SUBJECT: Mill Street West Parking Stalls

MEETING DATE: Tuesday, July 6, 2021

PLAN	
2021 STREET PROJECT CANNON FALLS, MINNESOTA 2021

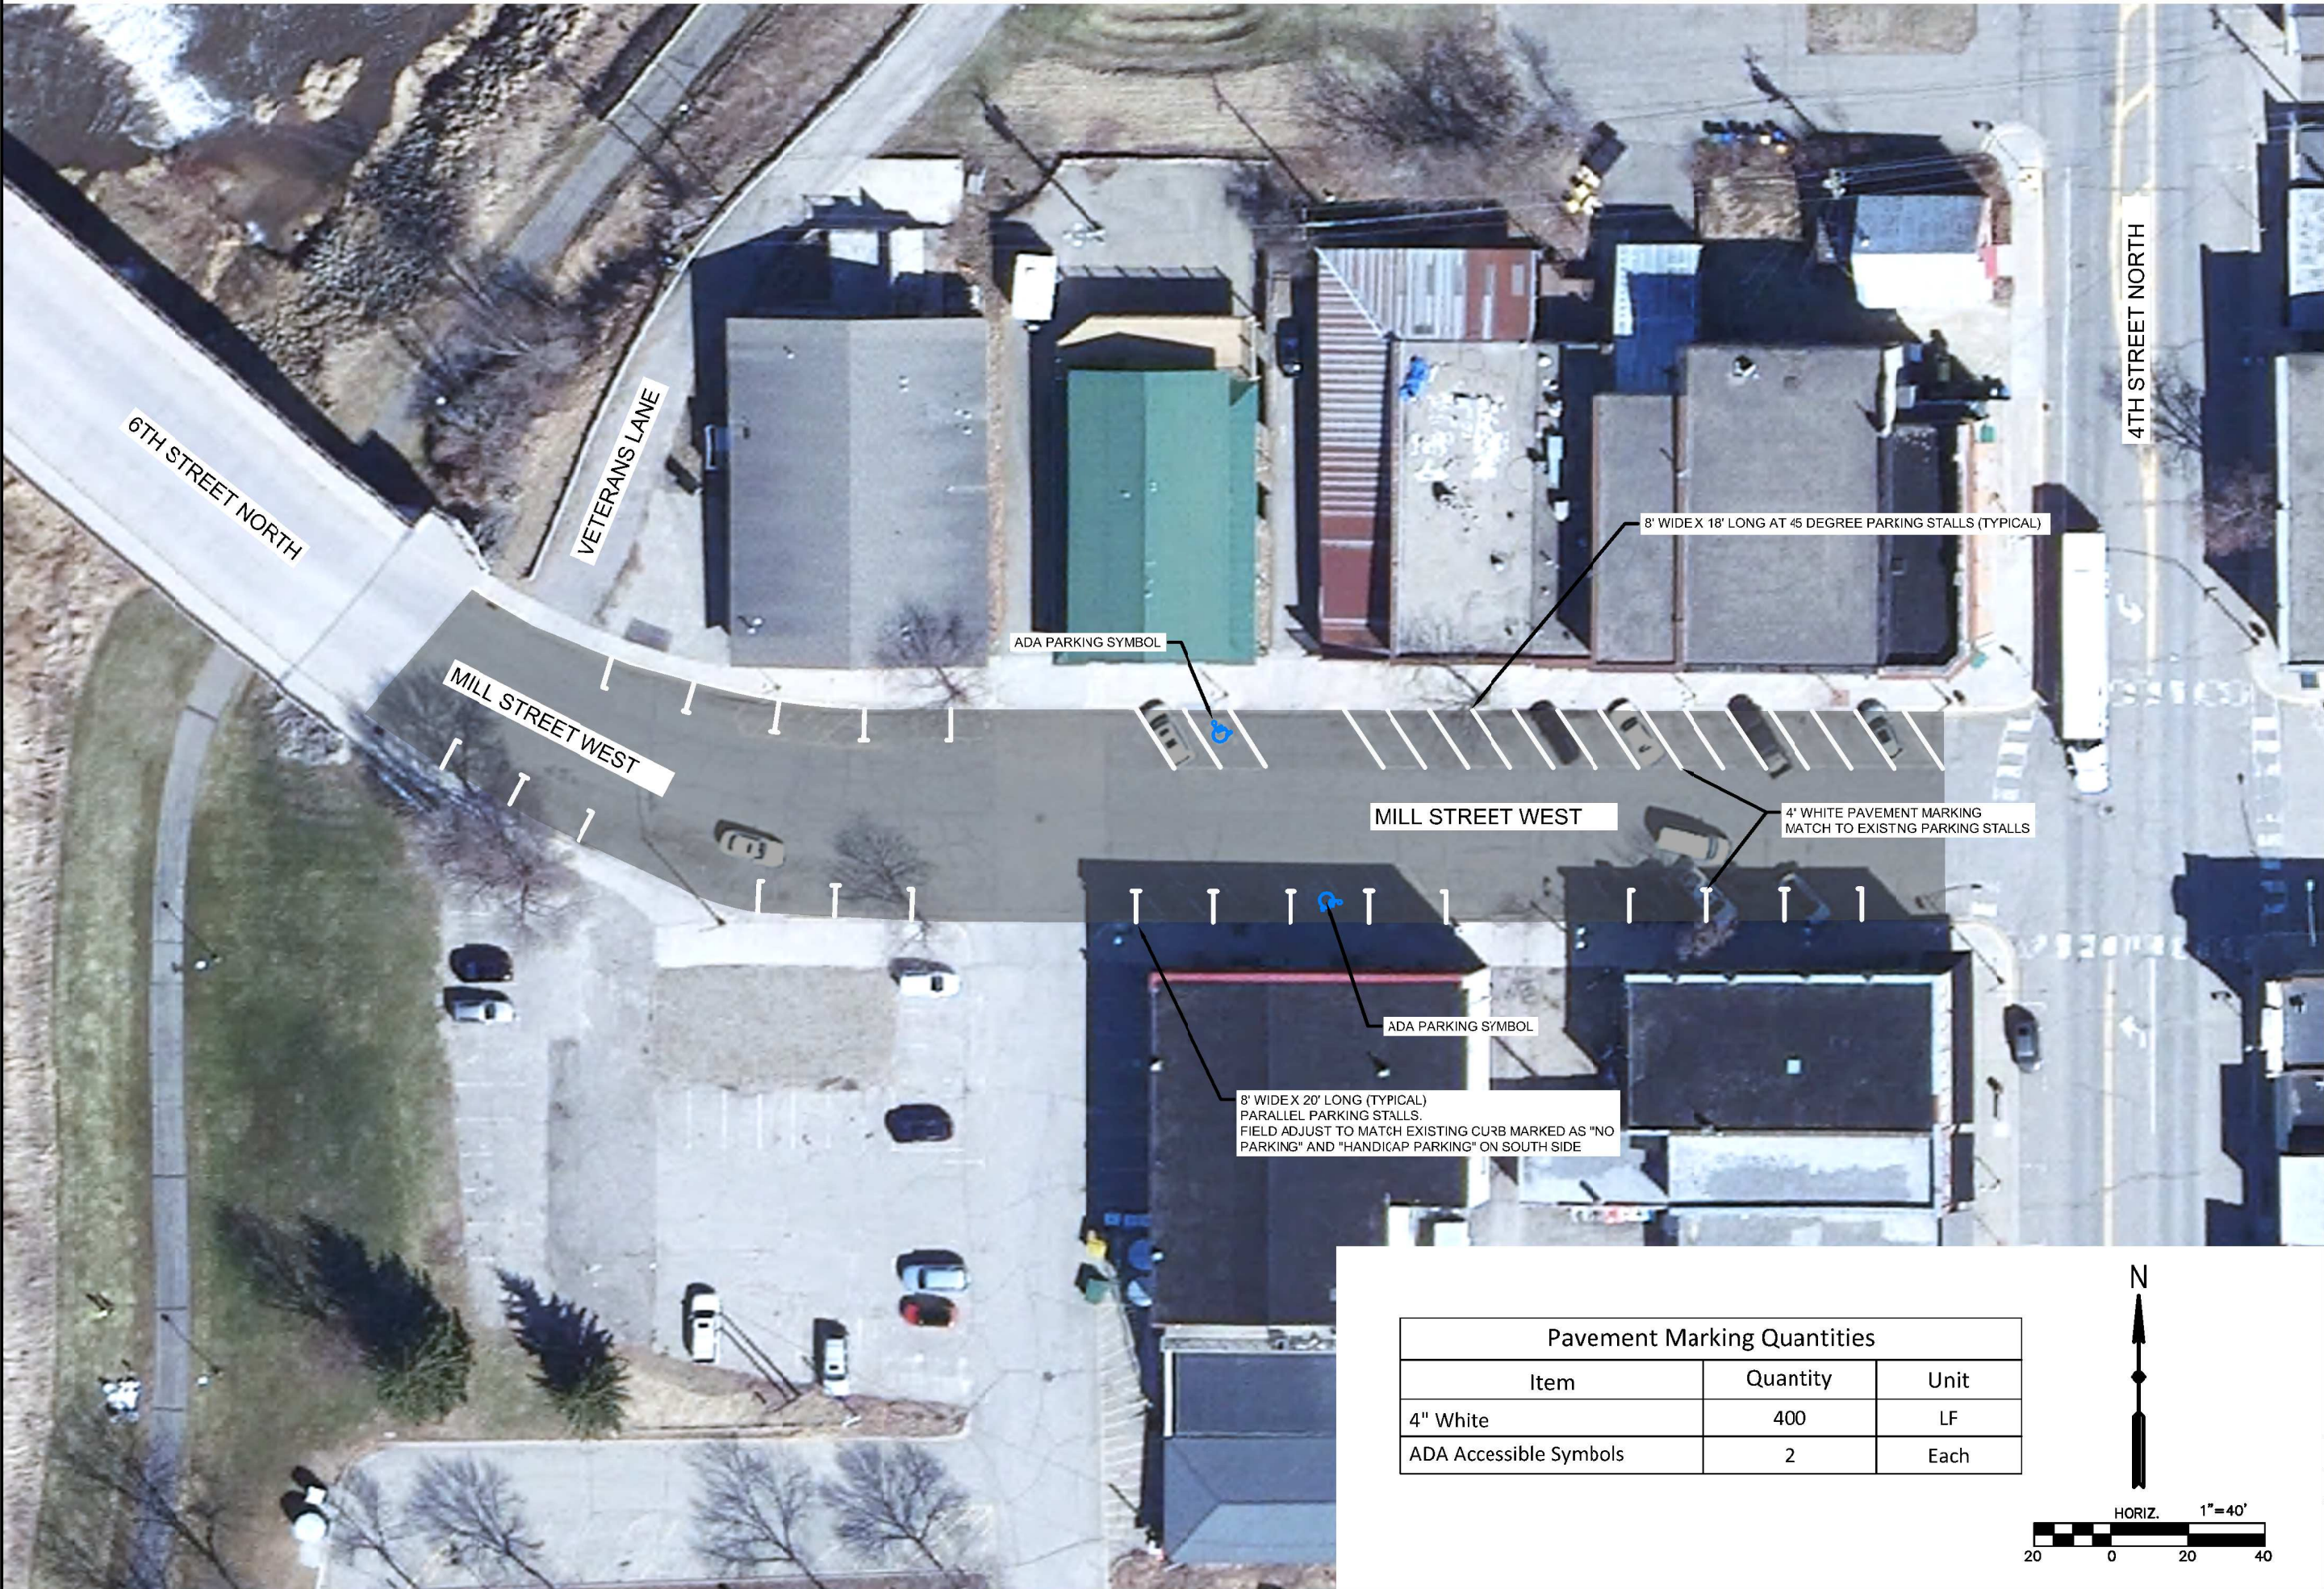
As part of the mill and overlay project on Mill Street West, we would like to suggest some changes and additions to the parking along Mill Street West. The parallel parking along the south side of Mill Street consisted of 16 foot long parking spaces. We would like to increase the length to 20 feet long, and add 2 additional spaces in front of the Lee Chevrolet parking lot and also add 1 more space near the bridge. On the north side we would like to change the parking to parallel in front of Tilion Brewery vice diagonal as it is difficult to see oncoming traffic from the east as you pull out of Veterans Lane. There would be 3 - 4 parking spaces.

REVISIONS	
NO.	DESCRIPTION
1	REVISED STRIPING

I respectfully request a motion and approval to make the above-mentioned striping changes to Mill Street West as recommended by the Public Works Commission.
